Access Compliance Report

Public Rights-of-Way

Intersection ID: 47904	Main Street: CAMP_VERDE_LN	Cross Street: ROUND_ROCK_RD	Location: NE
ADA ID: 585CE68ED30A	Ramp Type: PerpDiag	Initial Pass/Fail: Fail	Overall Compliance: No
Severity Score: 36.25			
Codes/Mitigation Info/Possible Solution		Field Measurements/Component Compliance

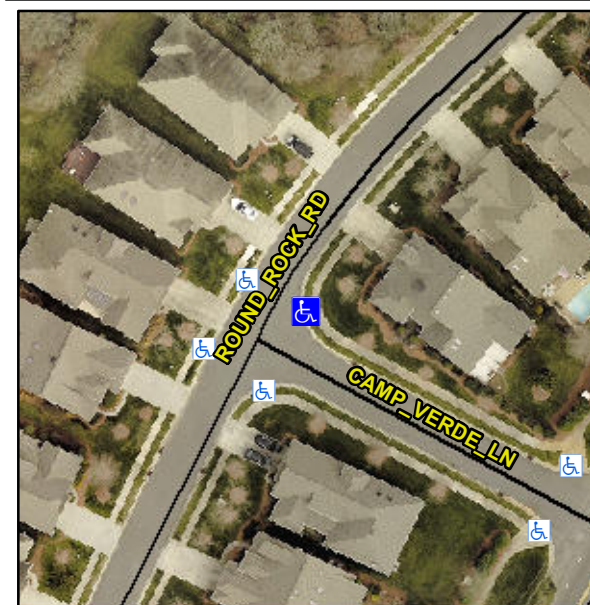
Not Found, R304.5.1, R304.5.3

Compliance	Description	Data	Compliance	Description	Data
N/A	Ramp Length (in)	49.0	Yes	Ramp Slope (%)	8.2
No	Ramp Width (in)	31.0	No	Ramp XSlope (%)	3.5
N/A	Flare Type LT	N/A	N/A	Flare Type RT	N/A
N/A	Flare Slope LT (%)	N/A	N/A	Flare Slope RT (%)	N/A
N/A	Flare Traversable LT?	N/A	N/A	Flare Traversable RT?	N/A
N/A	Landing Length (in)	N/A	N/A	DWS Provided?	N/A
N/A	Landing Width (in)	N/A	N/A	DWS Contrast?	N/A
N/A	Landing Slope (%)	N/A	N/A	DWS Length (in)	N/A
N/A	Landing X Slope (%)	N/A	N/A	DWS Full Width?	N/A
N/A	Landing Curb? (Y/N)	N/A	N/A	DWS Offset (in)	N/A
N/A	Shared Landing?	N/A			
N/A	Gutter Ponding?	N/A	N/A	Gutter Slope (%)	N/A
N/A	Gutter Lip Ht (in)	N/A	N/A	Gutter X Slope (%)	N/A
N/A	Painted X Walk1?	No	N/A	Painted X Walk2?	No
	X Walk 1 Direction	To NW		X Walk 2 Direction	To SW
N/A	X Walk 1 Width (in)	N/A	N/A	X Walk 2 Width (in)	N/A
	X Walk 1 Slope (%)	1.5		X Walk 2 Slope (%)	1.7
	X Walk 1 X Slope (%)	0.3		X Walk 2 X Slope (%)	2.6

Remove & Replace Curb Ramp With Two New Directional Ramps or Equivalent.
